RAPID CITY REGIONAL AIRPORT**ADDENDUM NO. 3**

**Request for Proposals – Integrated Terminal Technology Package
Comprising CUPPS, CUSS, MUFIDS (Including GIDS and BIDS), and Digital Backwall Video Signage
Rapid City Regional Airport**

Date of Issuance: August 12, 2026

**RAPID CITY REGIONAL AIRPORT
RENOVATION AND EXPANSION PROJECT
PROJECT 1 PHASE 3**
Rapid City, South Dakota

I-404

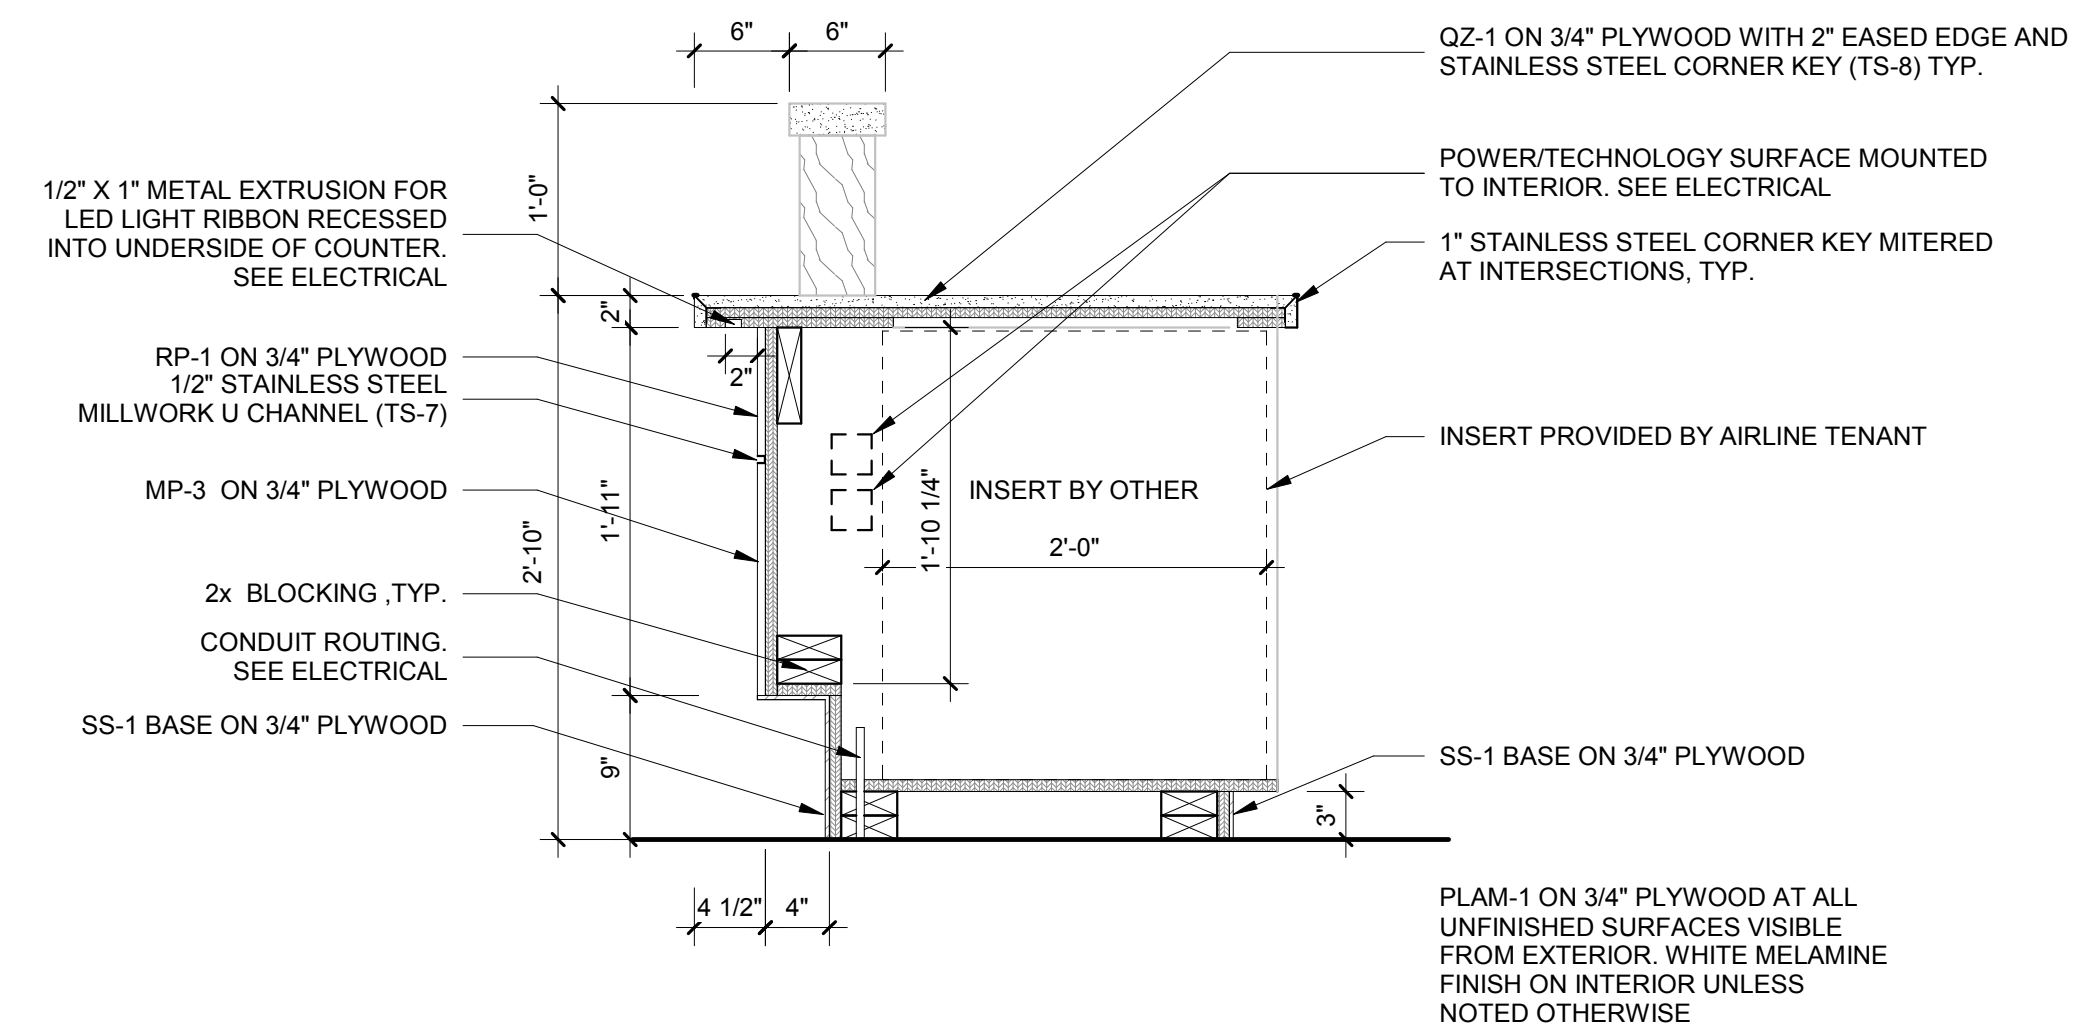
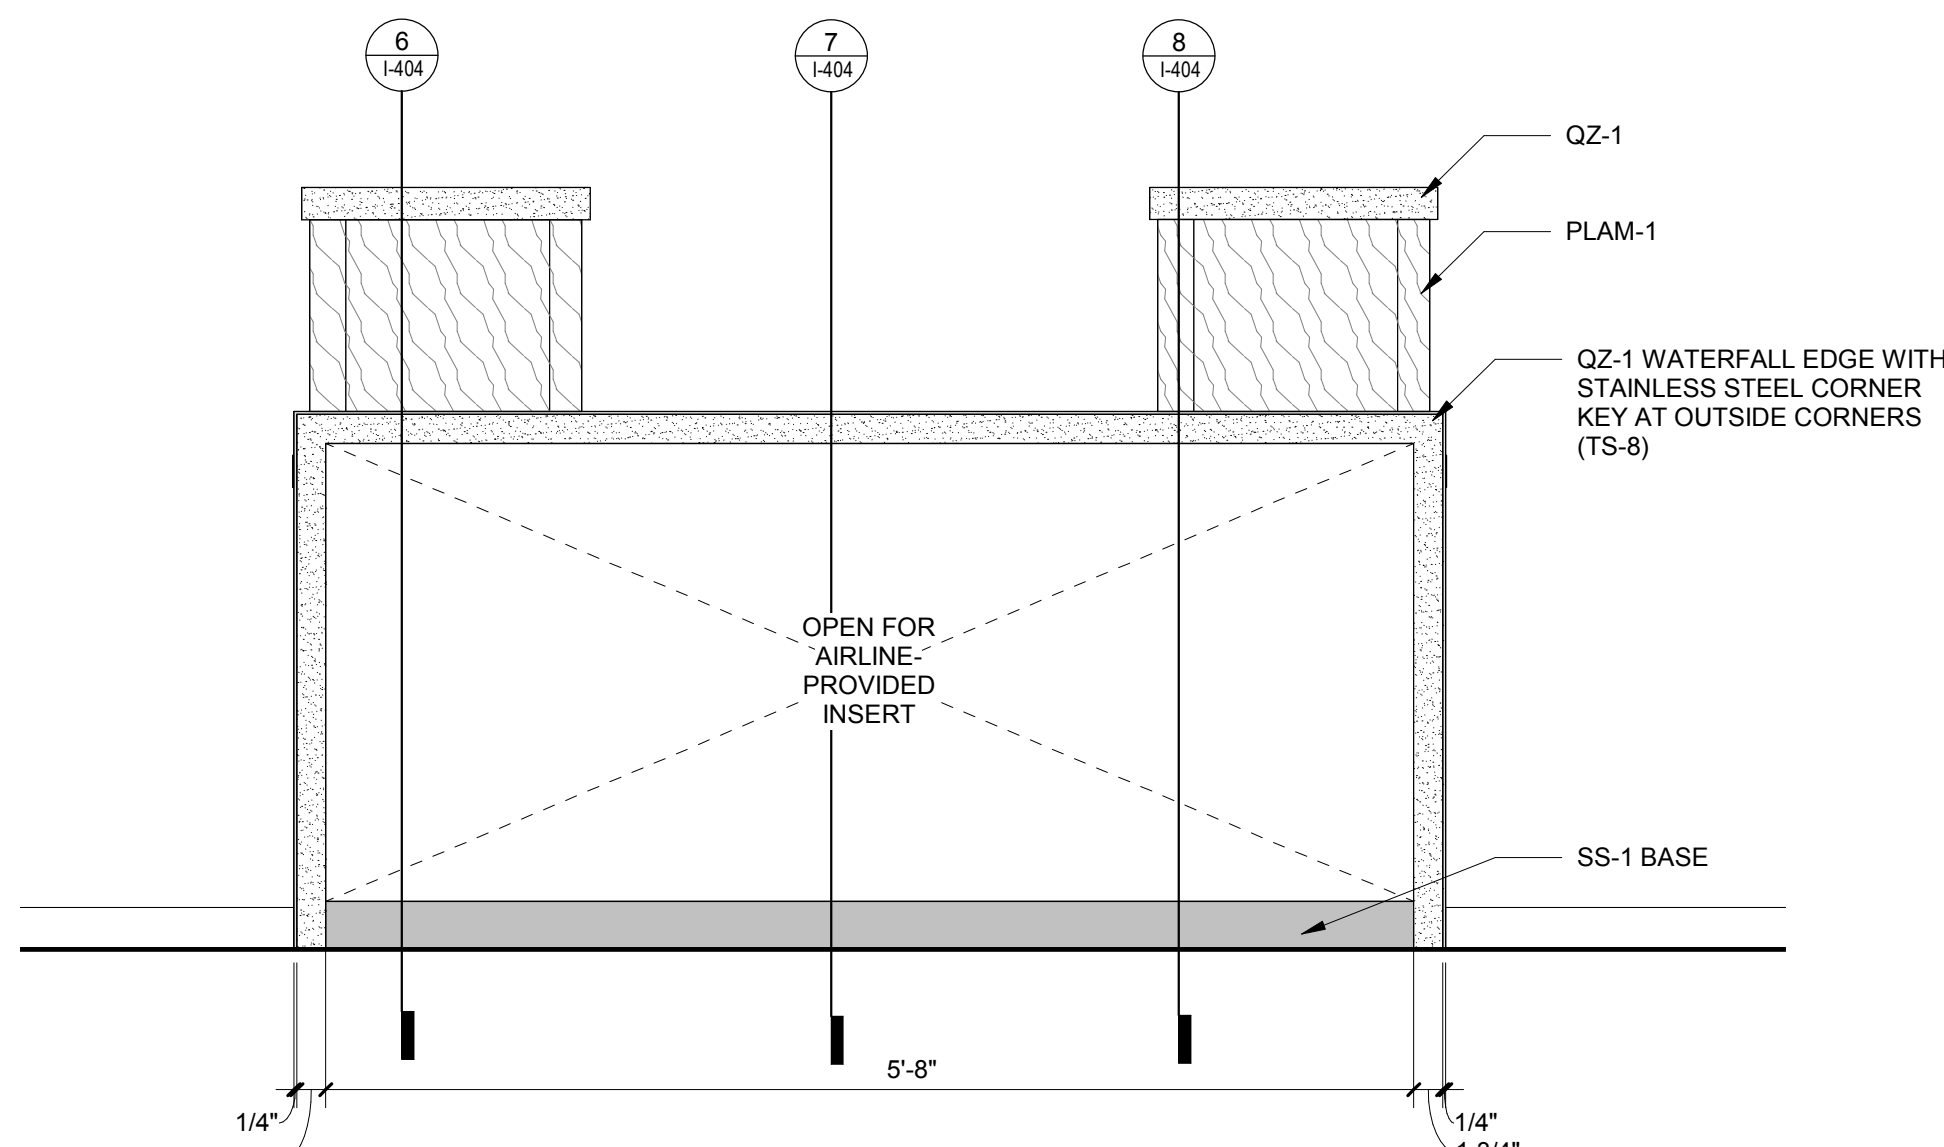
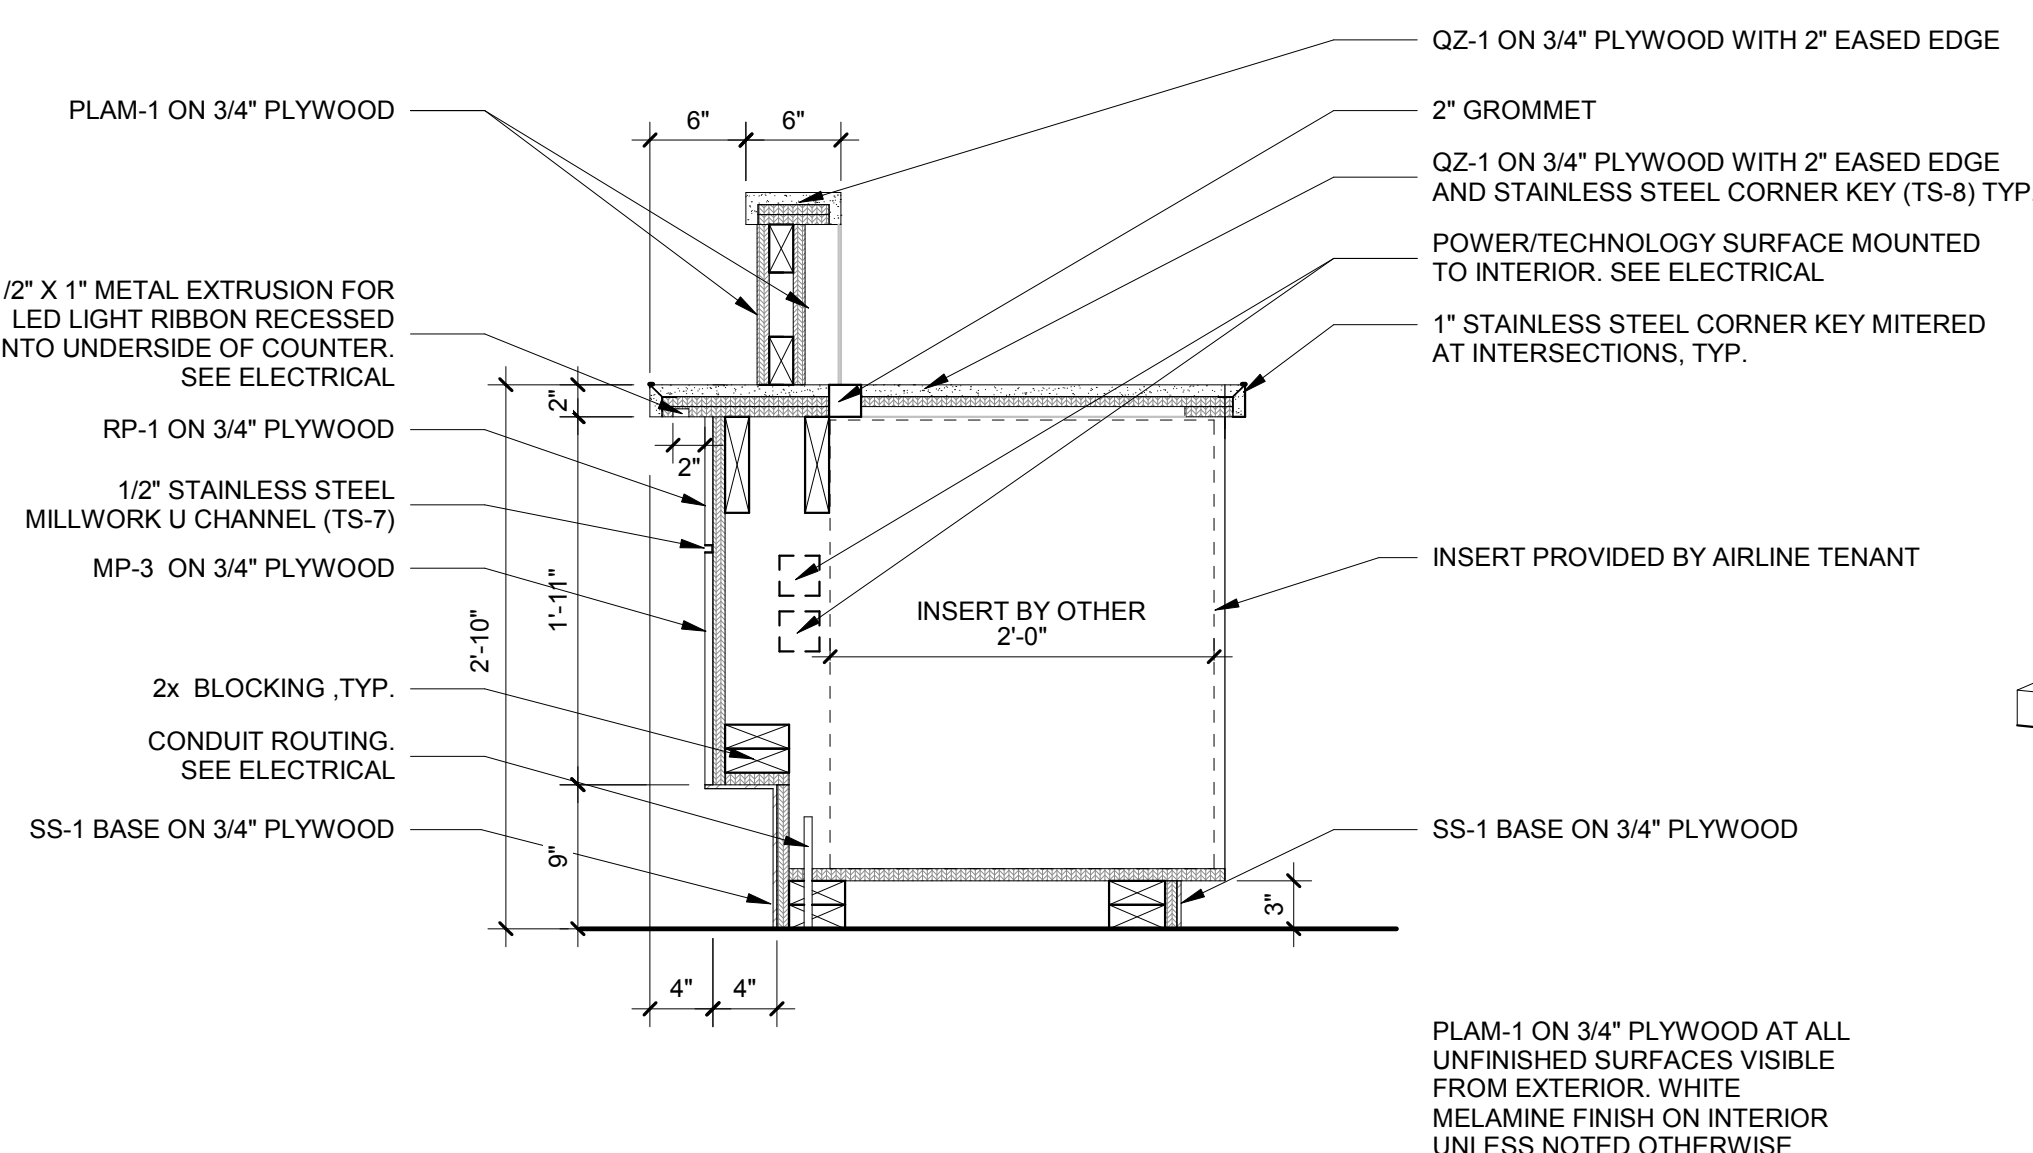
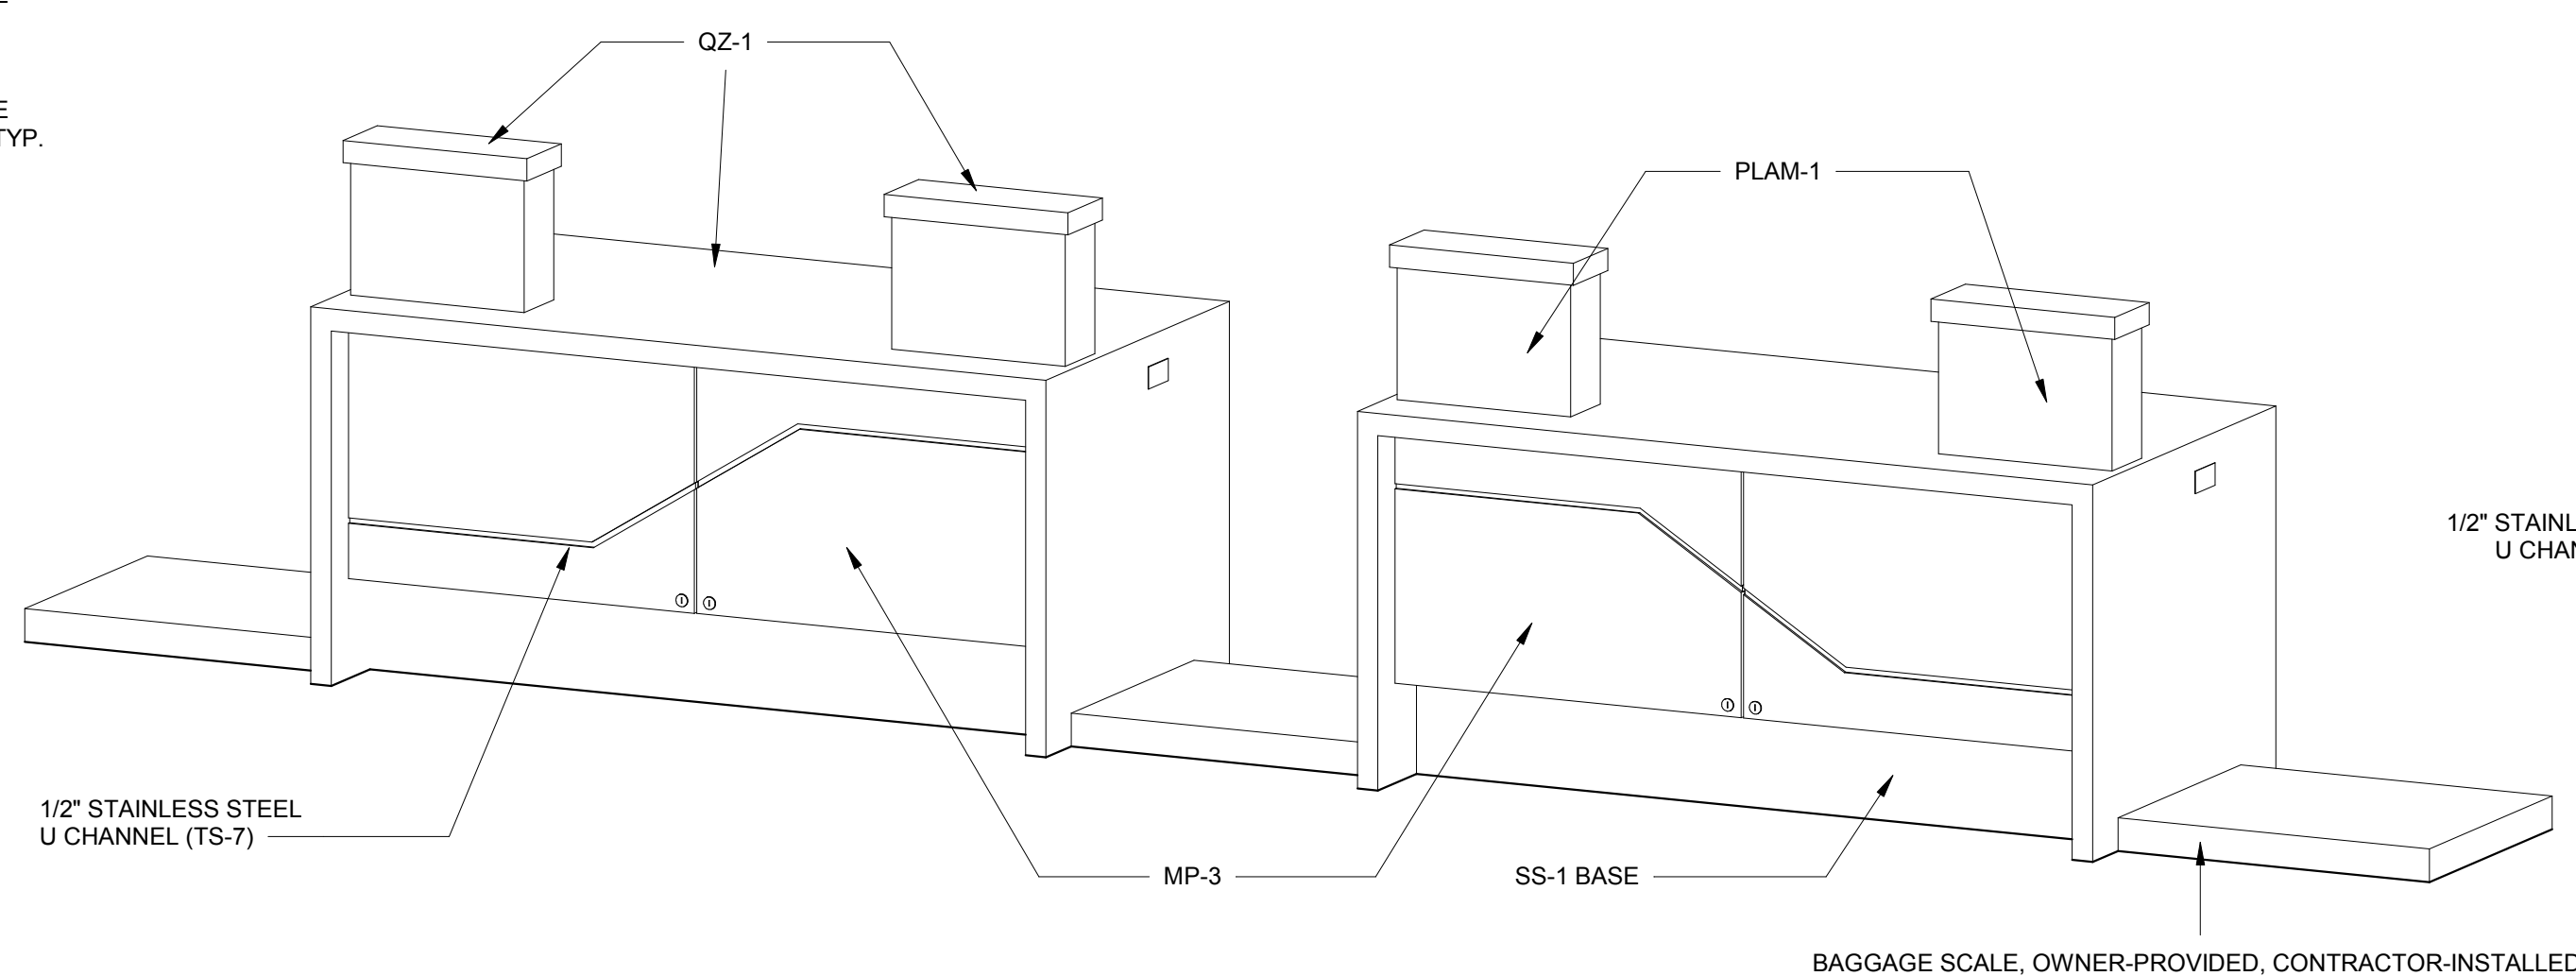
- Attachment 5 – Sheet I-404, Enlarged Ticketing Plans, Elevations, and Details. Each ticket counter module is 8'-0" wide and accommodates two agent positions, consistent with the nine-counter, two-station configuration priced under Section 5.2.1. The baggage scale is Airport-owned and Contractor-installed, with the scale reader integrated into the countertop; it is not a separate CUPPS/CUSS-furnished peripheral. Each position includes a cutout reserved for airline-provided equipment inserts, separate from the Common Use workstation footprint.
- Attachment 6 – Sheet I-407, Enlarged Gate Counter Plans, Elevations, and Details. Each gate counter module is 8'-0" wide and similarly accommodates two agent positions.

Proposers shall size Common Use workstation hardware, peripherals, and cabling to fit within the counter and gate module envelopes shown on Attachments 5 and 6.
